PROJECT: SES Solar One

- The Applicant's Responses to CURE Data Requests, Set One

In Response to CURE Data Requests
Set I: Data Requests 1-228

Application for Certification (08-AFC-13)

TITLE:
**SES SOLAR ONE LLC
HYDROLOGY MAP**

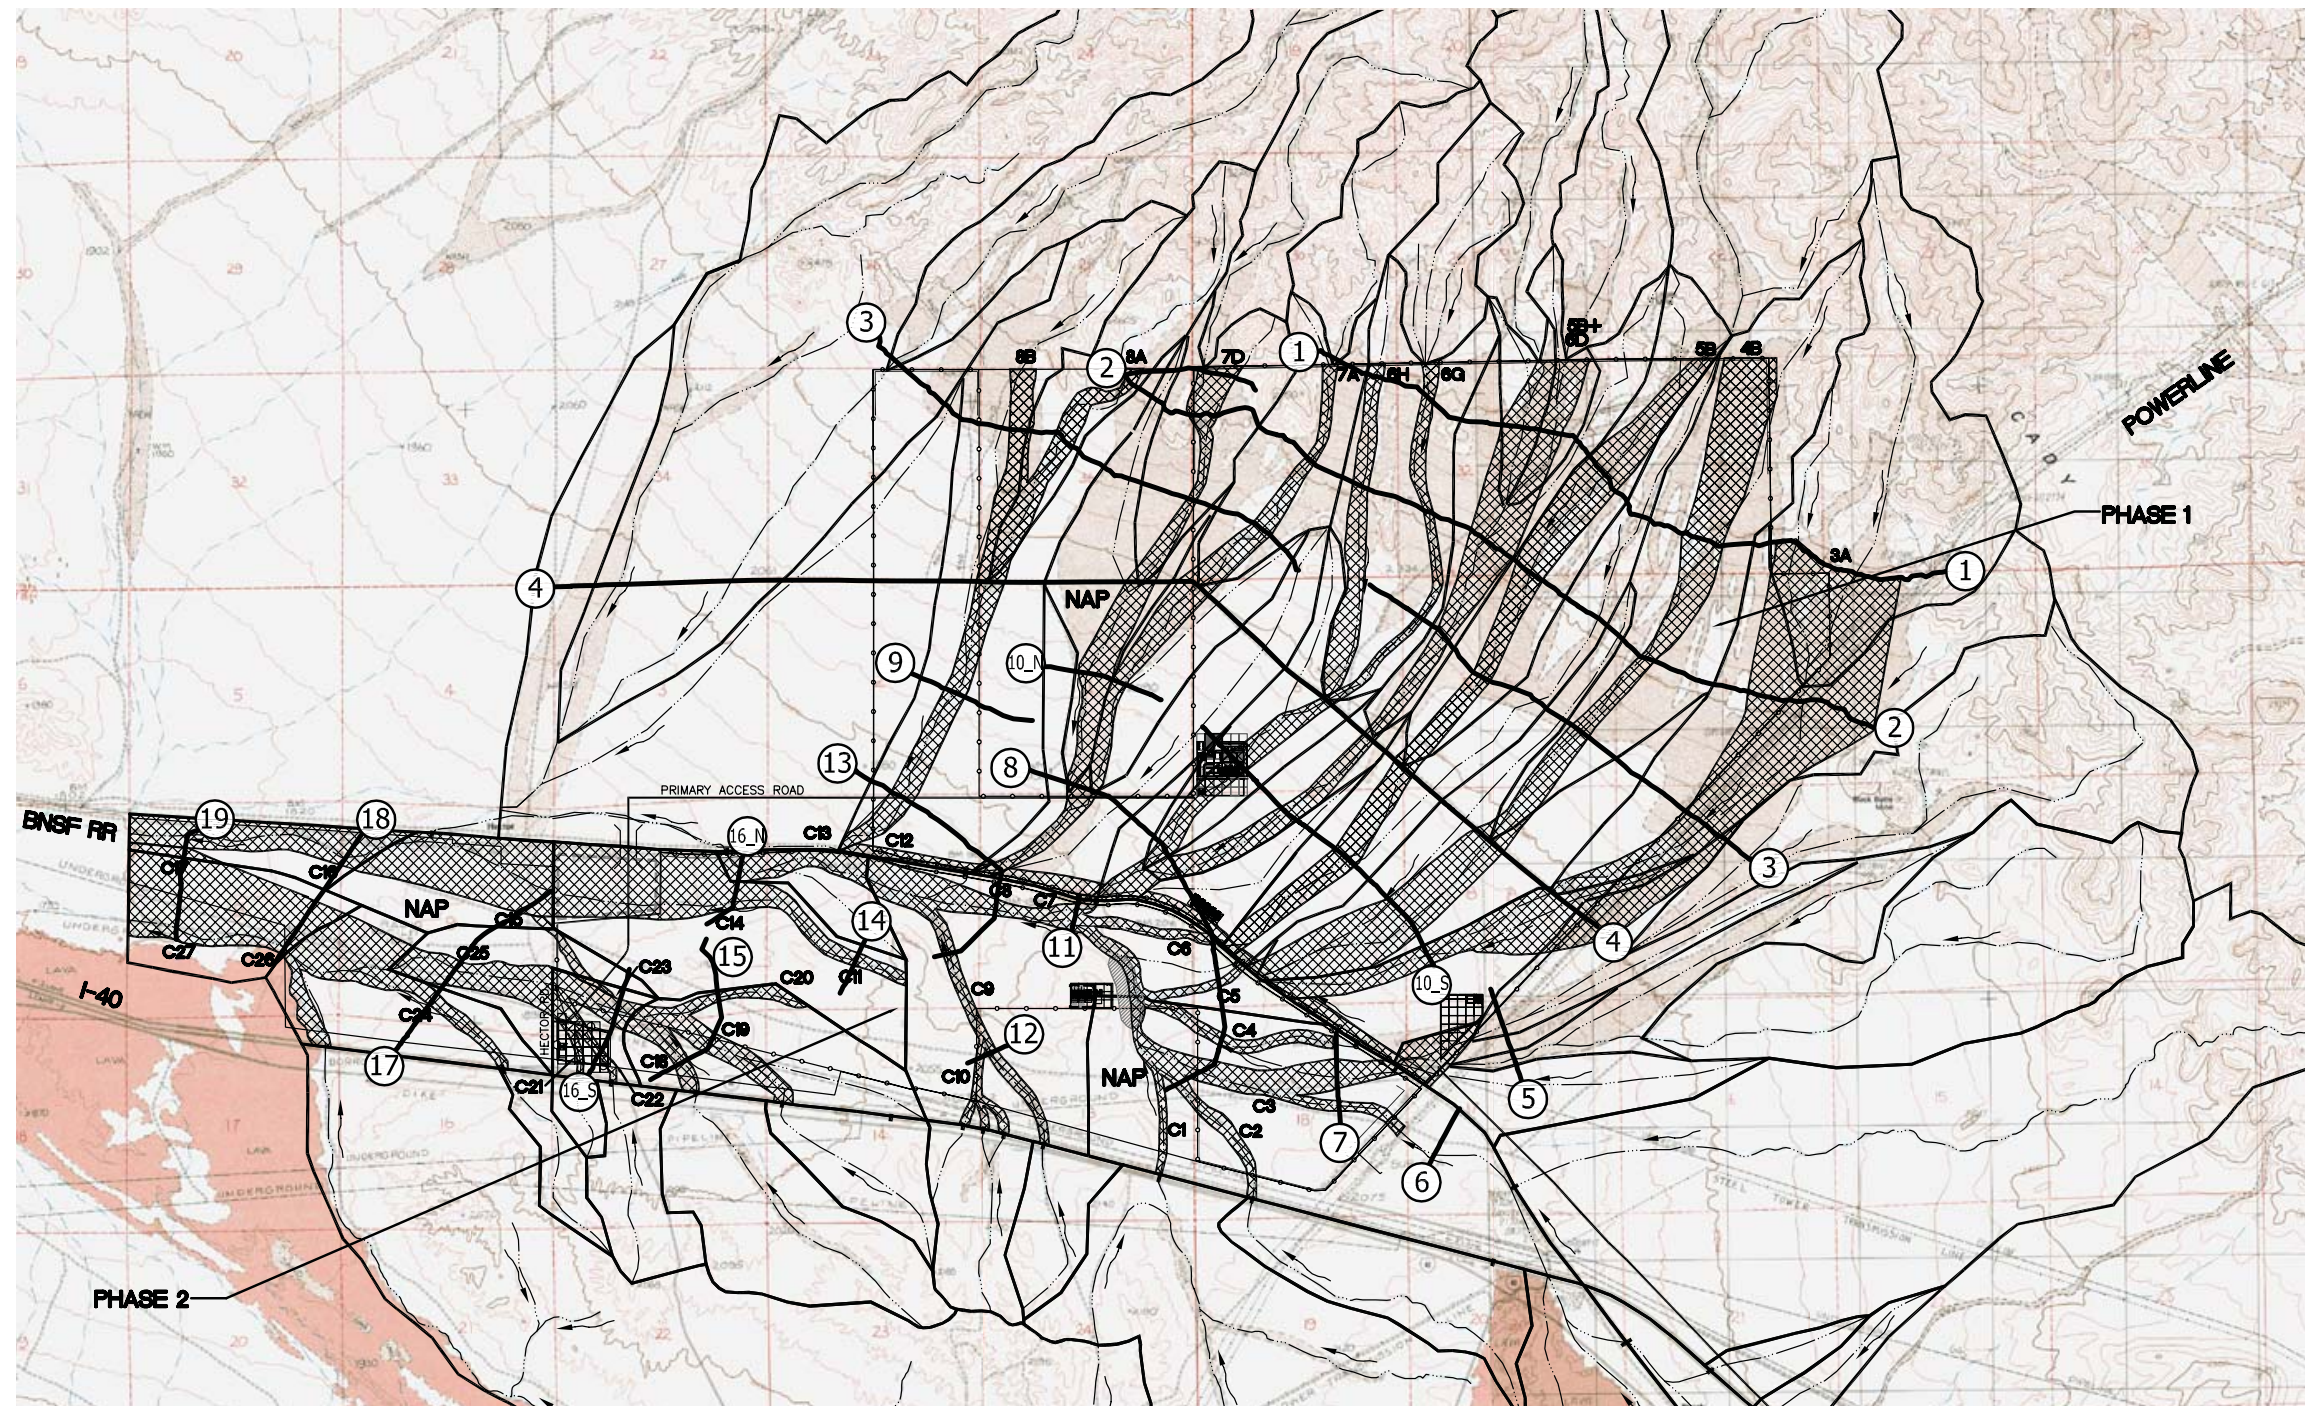
Data Request 227: Please provide legible maps and legends for AFC Figures 5.5-3 and 5.5-4.

Response: Legible versions of Figures 5.5-3 and 5.5-4 are provided behind this response as attachment BIO-5.
